ARCHITECTURAL REVIEW BOARD STAFF REPORT

Project #/Name	ARB-2020-82: Valvoline Final Site Development Plan
Review Type	Review of a Final Site Development Plan and Architectural Design
Parcel Identification	04500-00-00-111C0
Location	East of 29 North, west of Gander Drive between Atlantic Union Bank and Goodwill
Zoned	Highway Commercial (HC), Entrance Corridor (EC)
Owner/Applicant	First Gold Leaf Land Trust / CESO (Kelly Schwieterman)
Magisterial District	Rio
Proposal	To construct a 2,080-sf oil change facility with associated site improvements on approximately .52 acres.
Context	The subject property is accessed by an internal road, Gander Drive, and is located within the Northtown Center development. Route 29 is largely characterized by commercial development with nearby developments including Rivanna Plaza across Route 29 to the west, Lowe’s and Rio Hill Shopping Center to the southwest, Harbor Freight and Goodwill in the former Gander Mountain store to the south, and another phase of the Northtown Center to the southeast. (See Figure 1.)

Figure 2: Comparative side elevations – March and June 2020.

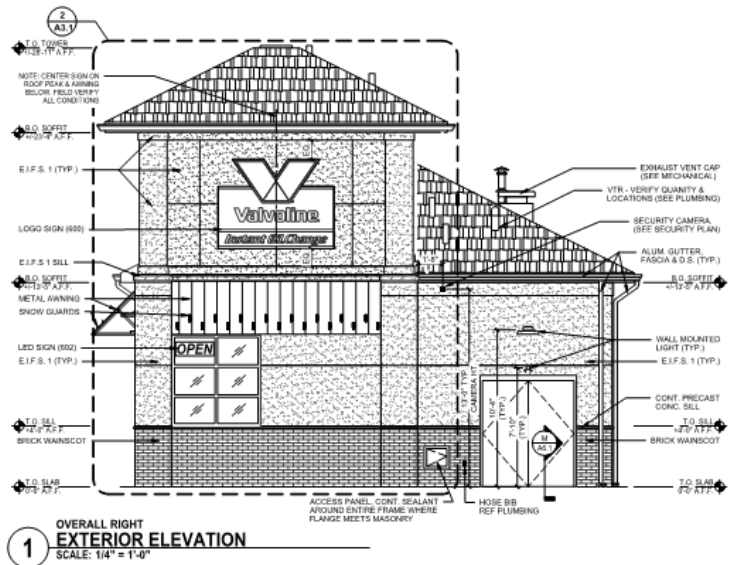
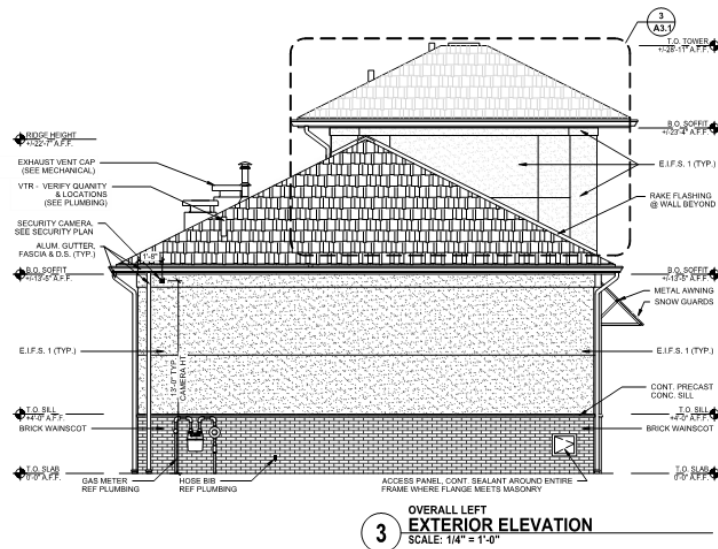
13	Any appearance of “blankness” resulting from building design should be relieved using design detail or vegetation, or both.	Revise the north elevation to incorporate additional design details to relieve “blankness”. Revise the design to better coordinate the window on the south elevation with the awning.	The north elevation has been revised to incorporate a 5’10” x 5’3” EIFS accent, which appears to be composed of a simple raised molding with no change in material or color. The molding does break up the EIFS wall, but the overall blankness remains. Revising the design to incorporate architectural changes rather than applique would be more appropriate. The south elevation has been revised to extend the window under the awning down to the ground and to add an EIFS accent in the blank wall area to the east of the window. Extending the window to the ground helps to visually connect it to the storefront bay on the façade; however, the EIFS accent does not coordinate with the window. Replacing the EIFS under the awning with brick or revising the EIFS accent to mimic the window size, configuration, and placement would create a more uniform appearance.	Revise the north elevation to incorporate architectural changes rather than applique to relieve “blankness”. Revise the south elevation to replace the EIFS under the awning with brick or revise the EIFS accent to mimic the window size, configuration, and placement create a more uniform appearance.

3. Revise the north elevation to incorporate architectural changes rather than applique to relieve “blankness”.
4. Revise the south elevation to replace the EIFS under the awning with brick or revise the EIFS accent to mimic the window size, configuration, and placement create a more uniform appearance.
